Town of Parker Community Development Department  
 Development Review Division  
 Attention: **Stacey Nerger**

Application Type: **Minor Development Plat**  
 Status: **First Referral**  
 Application Name: **Lincoln Professional Park Filing No. 1 MDP**  
 Case/AP#: **SUB20-002**  
 Referral Received: September 22, 2021  
 Comments Due: October 20, 2021

Review date: **October 14, 2021**  
 Plan reviewer: **Randall L. Capra, [rcapra@parkeronline.org](mailto:rcapra@parkeronline.org)**  
 Phone: 303.805.3163

<b>TOWN OF PARKER</b>	<b>FIRE/LIFE SAFETY DIVISION:</b>	<b>R REVIEWED FOR CODE COMPLIANCE; REVISIONS REQUIRED</b>
-----------------------	-----------------------------------	---

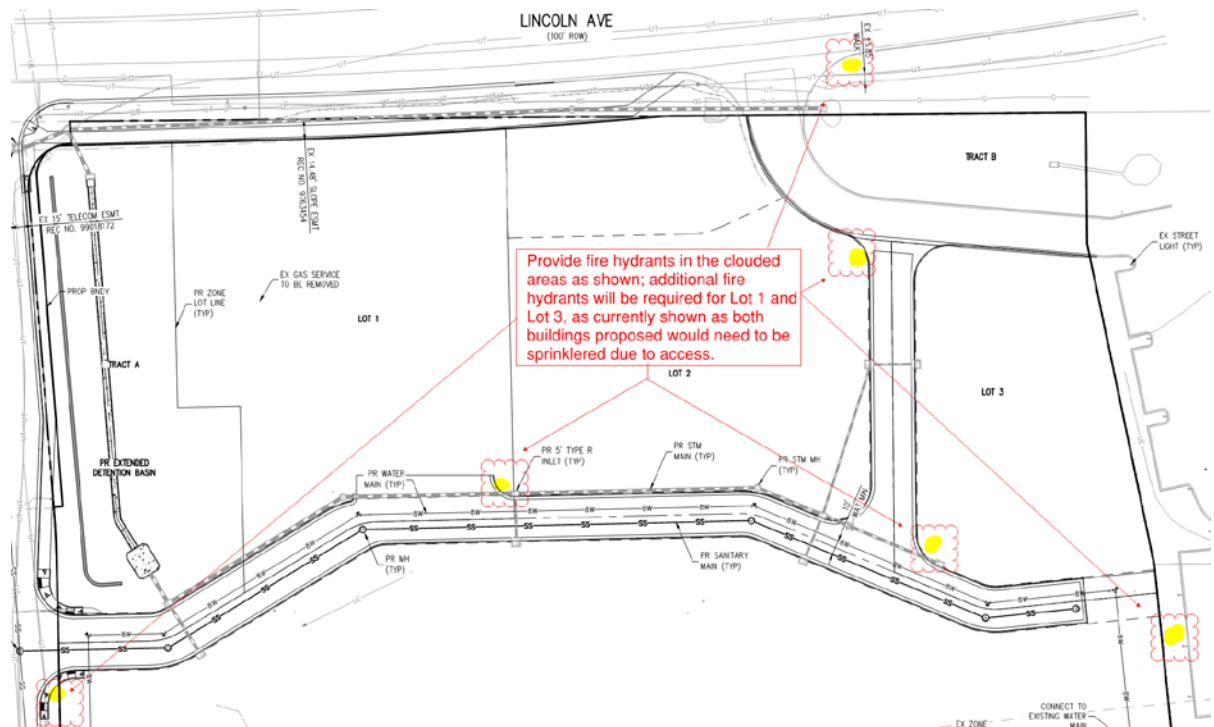
**UNRESOLVED ISSUES/COMMENTS**

See below the following and address all comments as required (**a written response is also required**):

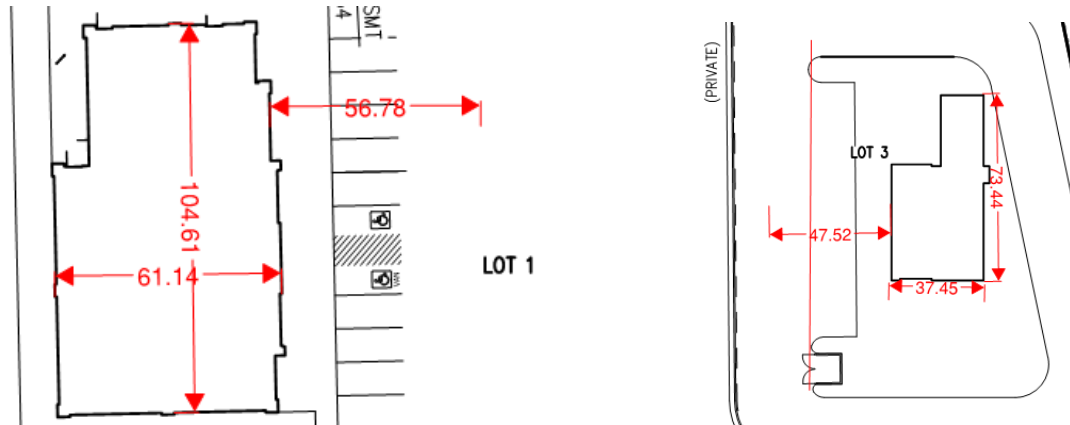
8. **Sheet 3 Overall Utility:** The overall utility drawings are incomplete; the plan set does not address fire hydrant locations for the spine roads proposed. The applicant shall address this issue and fire hydrants will be required in the following locations while noting that additional hydrants will be required on the internal lots depending upon access and use (the gas station will be required to be sprinklered as will Lot 3... as currently shown):

- The entry off of Dransfeldt Road on to Road A
  - The entry off of Lincoln Ave and the current Private Drive
  - Road A (required extension) into Lot 1 Filing No.2 Peaslee Subdivision at Road A and Lot 1

- At the corner of Road B and the Private Drive
  - At the corner of Road A and Road B
  - At the entry of the gas station off of Road A

See below for locations required:
